LOXAHATCHEE RIVER DISTRICT

AGENDA
REGULAR MEETING #13-2022
SEPTEMBER 15, 2022 – 7:00 PM AT DISTRICT OFFICES
ALSO, THE MEETING WILL BE AVAILABLE TO THE PUBLIC ONLINE AT:
LOXAHATCHEERIVER.ORG/PUBLICMEETING

- A. Manual of Minimum Construction Standards and Technical Specifications – to ratify revisions [Page 14](#)
- B. Money Purchase Plan and Trust (Retirement Plan) – to approve minor revision [Page 138](#)

Staff have implemented a Standards Review Committee to manage change control of the construction standards and technical specifications. This Committee meets quarterly and follows strict procedures governing change requests, investigation, recommendation/authorization and implementation of changes to the construction standards and technical specifications.

BOAC-001

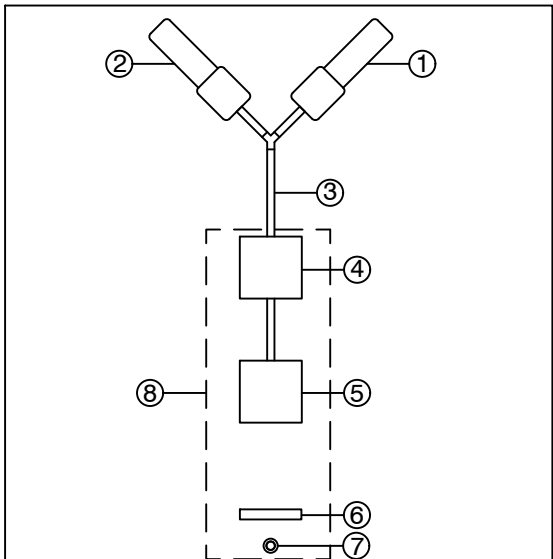
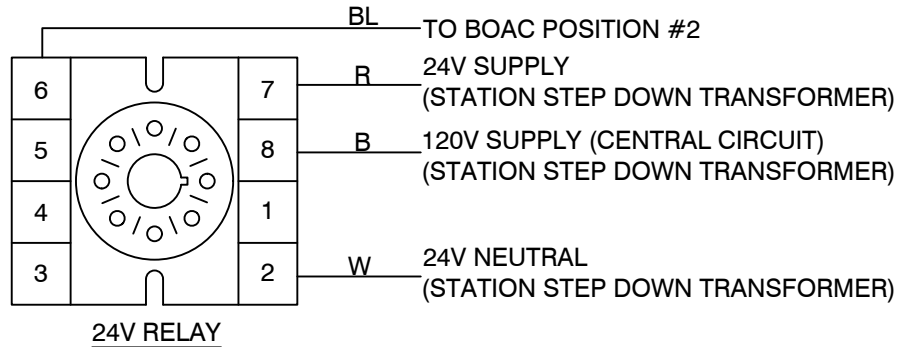
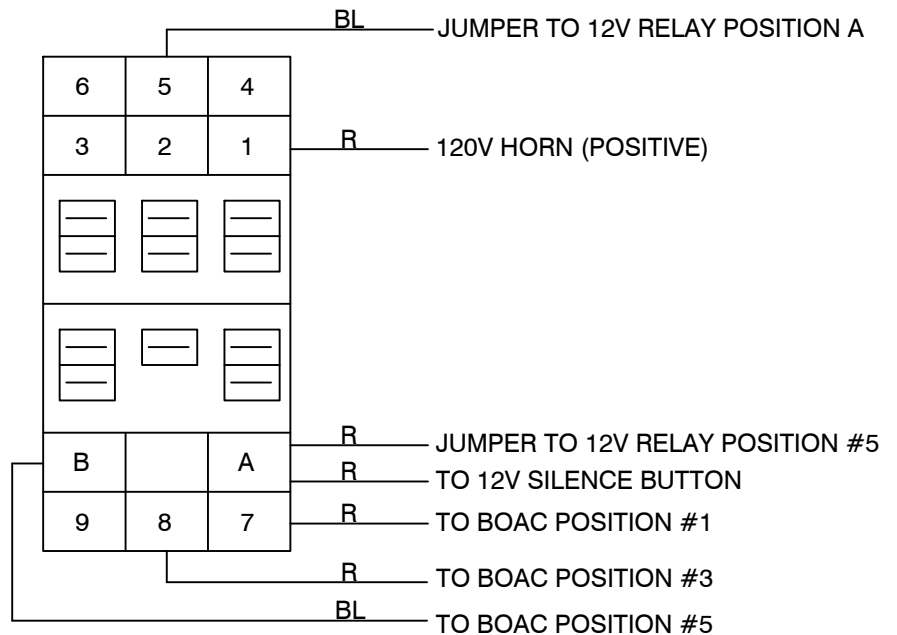
7. Section 160.14 – Removed preferred system integrator requirements.
8. Section 200 – Revised current officers.
9. Standard Detail COL-BBA – New Standard Detail for internal use only to retrofit alarms at existing lift stations only.

LP-17A

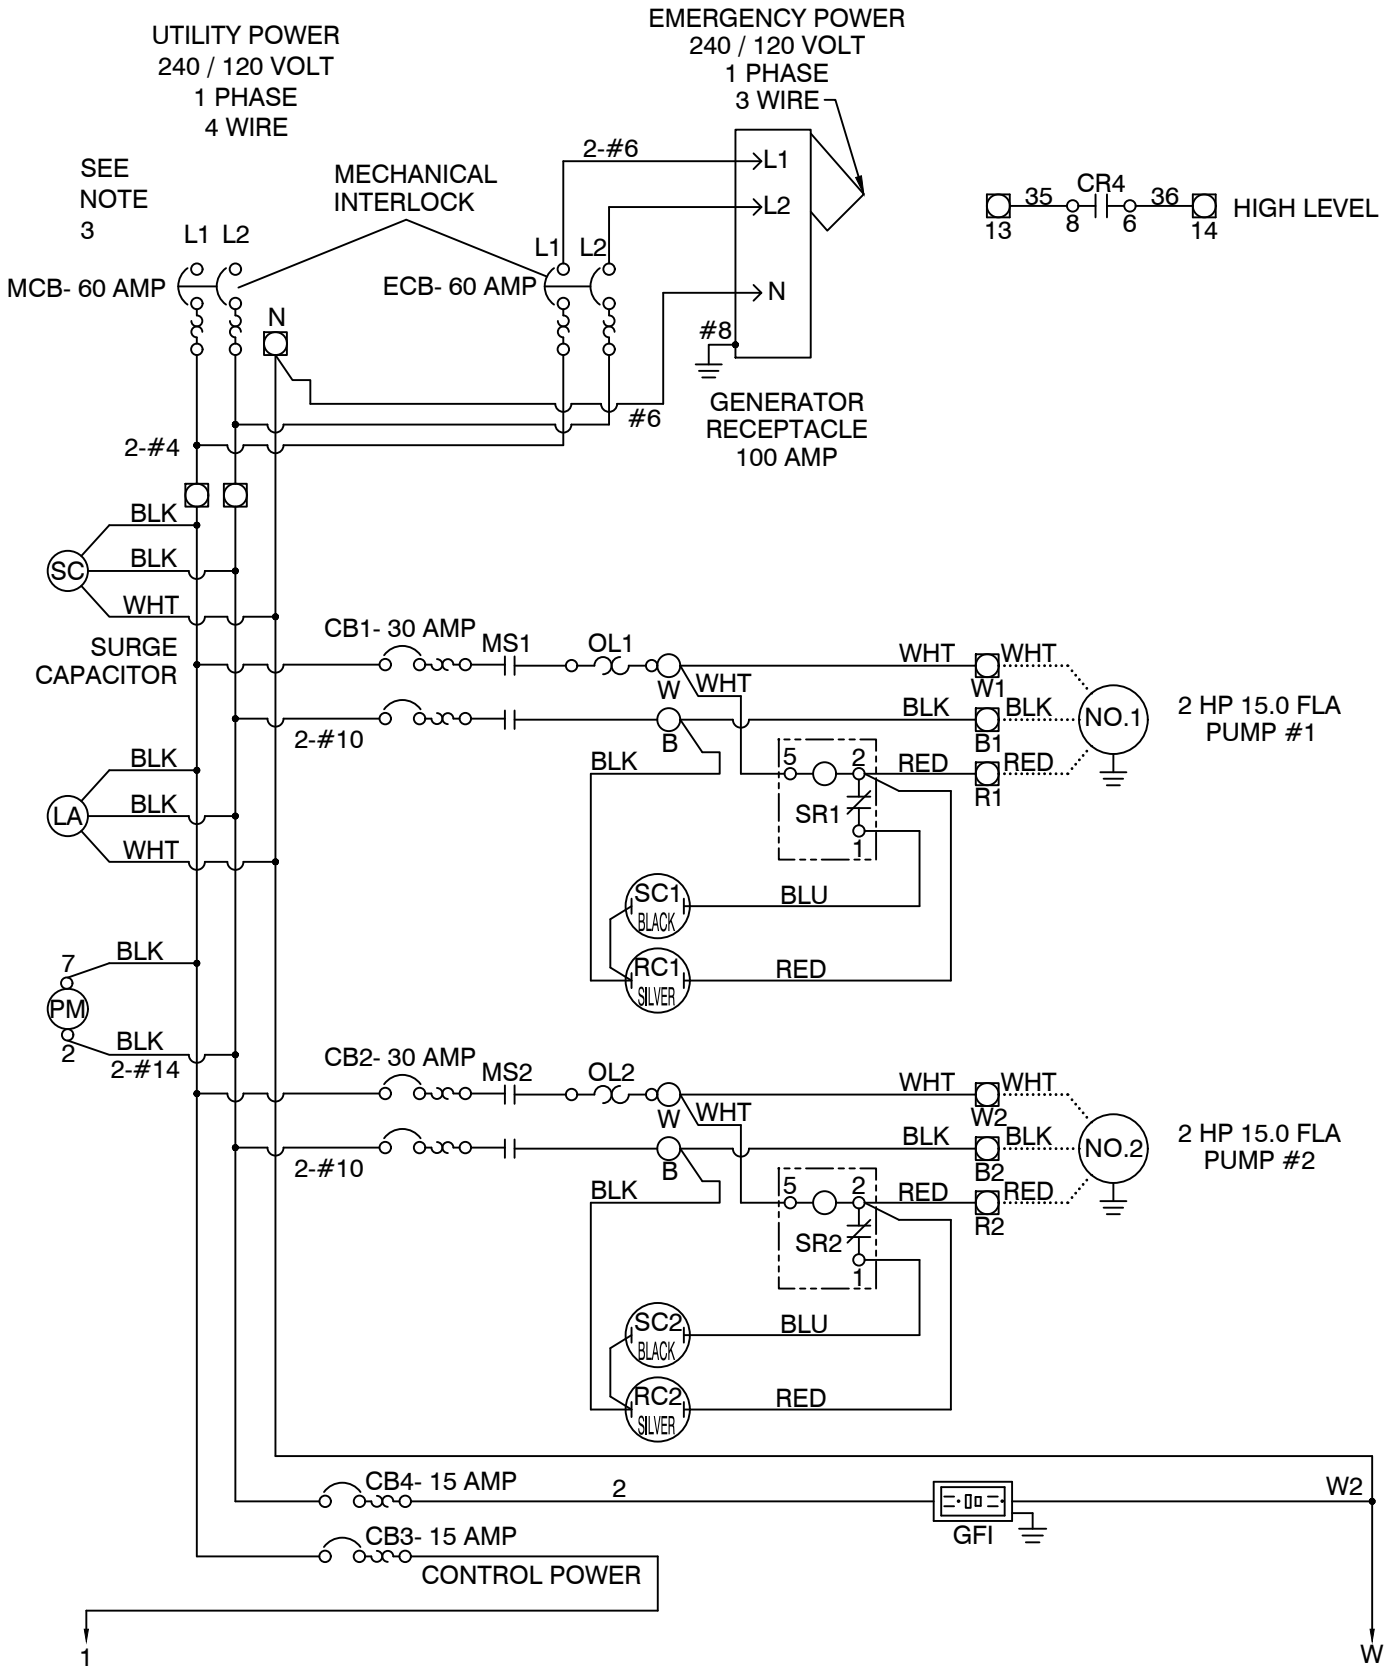
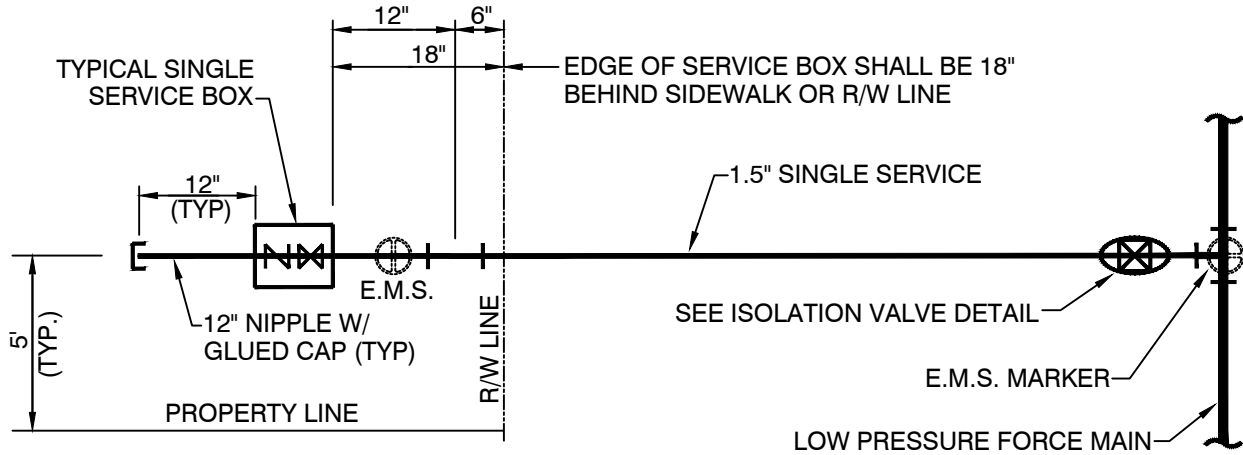
12. Standard Detail LP-16 – Updated to require same enclosure for both standard Commercial Duplex and Low-Flow Option.
13. Standard Detail LP-17A – New Standard Detail for consistency. LP-17A is the electrical schematic detail that corresponds with Standard Detail LP-12 ALT.

N.T.S.	6" DOUBLE SERVICE CONNECTION DETAIL	SD-8
REVISION: JUNE, 2022

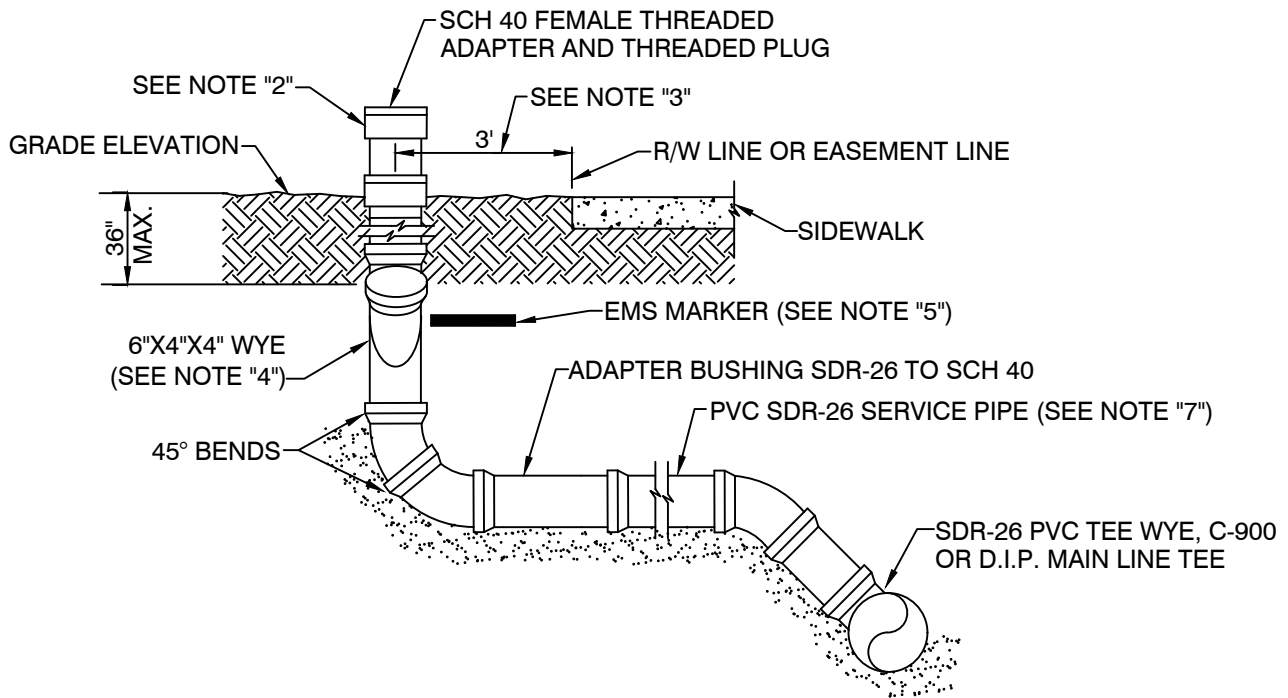
20. Standard Detail SD-8 – Note 9 added to further clarify cut and cap procedures.
21. Standard Detail SD-9 – Note 9 added to further clarify cut and cap procedures.

8. WHEN APPROVED BY THE DISTRICT, CLEAN-OUTS MAY BE PLACED IN PAVED AREAS, HOWEVER, PROTECTIVE BOXES AS SHOWN ON DETAIL SD-1 MUST BE INSTALLED.
9. CUT AND CAP SHALL BE PERFORMED ON 12" NIPPLE NOT MORE THAN 12" FROM WYE.

N.T.S.	AUTOMATIC AIR RELEASE VALVE DETAIL	SD-24
REVISION: SEP, 2022

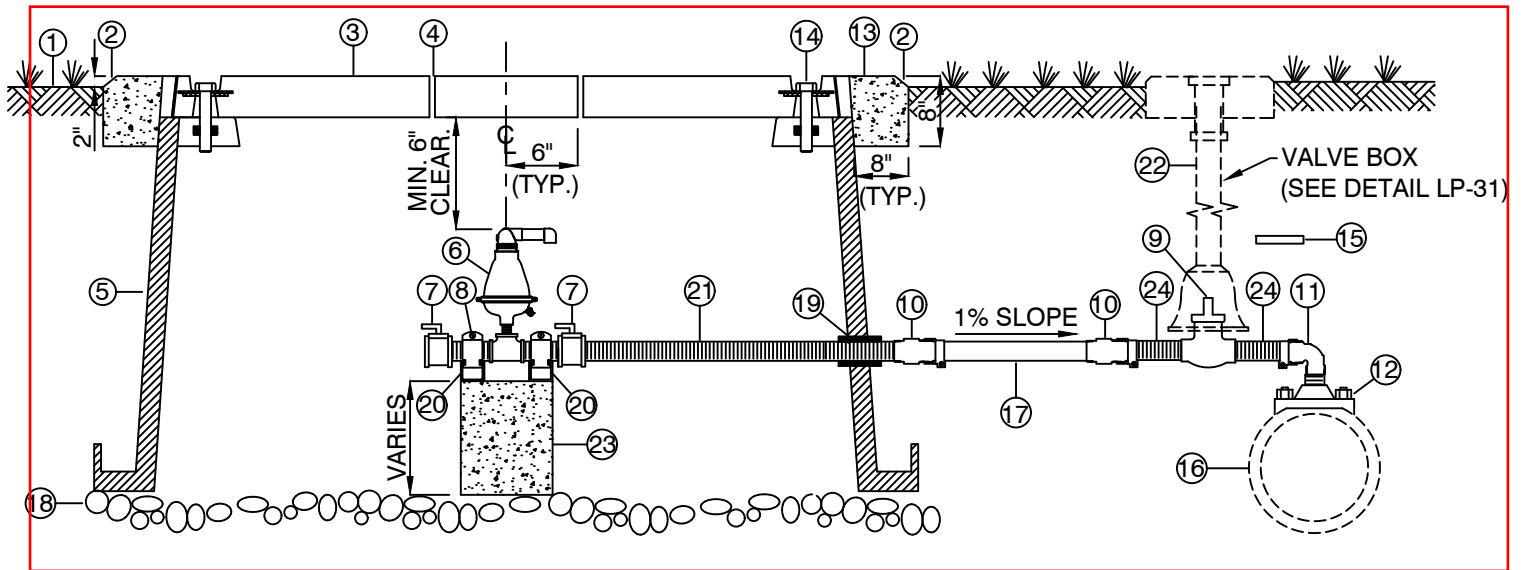
24. Standard Detail SD-24
 - a. General clean-up of notes for consistency and clarity.
 - b. Updated notes to specify that all materials, hardware, etc. within the manhole shall be minimum 304 stainless steel.

1. ALL MATERIAL, FITTINGS, VALVES, NIPPLES, AND HARDWARE TO BE MIN. 304 SS INSIDE MANHOLE.
2. VALVES SHALL HAVE ALL LOCKING MECHANISMS REMOVED, BE IN THE UPRIGHT POSITION, ACCESSIBLE AND OPERATIONAL VIA VALVE KEY FROM ABOVE.
3. CENTER ARV UNDER MANHOLE OPENING.
4. TOP OF AIR RELEASE VALVES SHALL BE NO LESS THAN 12" FROM INSIDE MANHOLE RIM ELEVATION AND NO GREATER THAN 24".
5. MANHOLE COVER SHALL BE MARKED "SEWER".

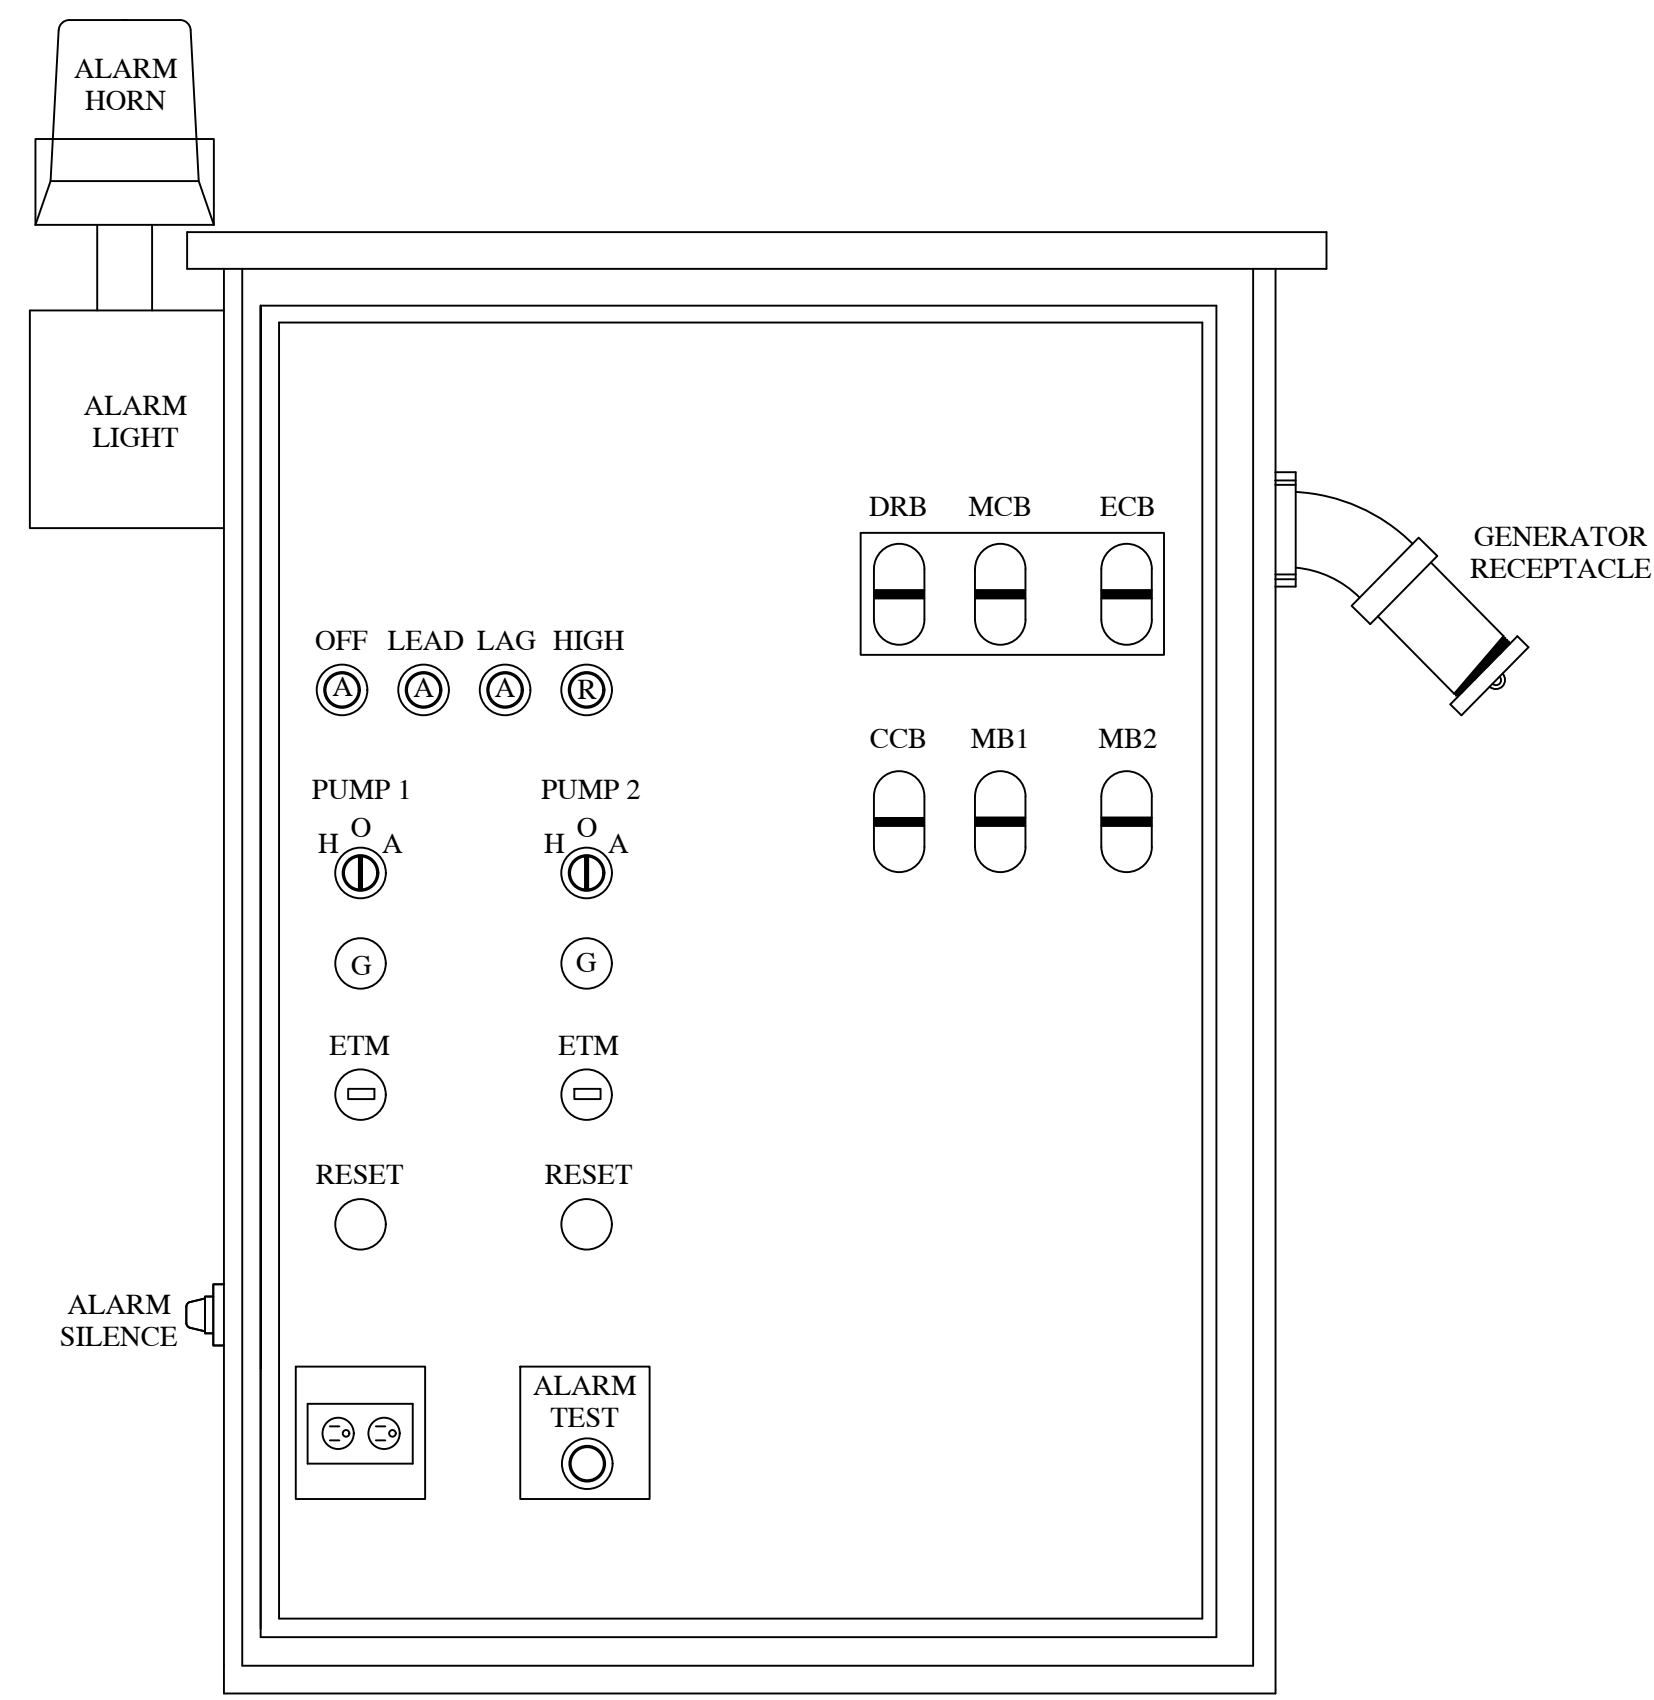
26. Standard Detail SD-29 – Updated references to latest version of AutoCAD and electronic submittal requirements.
27. Standard Detail SD-31
 - a. General clean-up of notes for consistency and clarity.
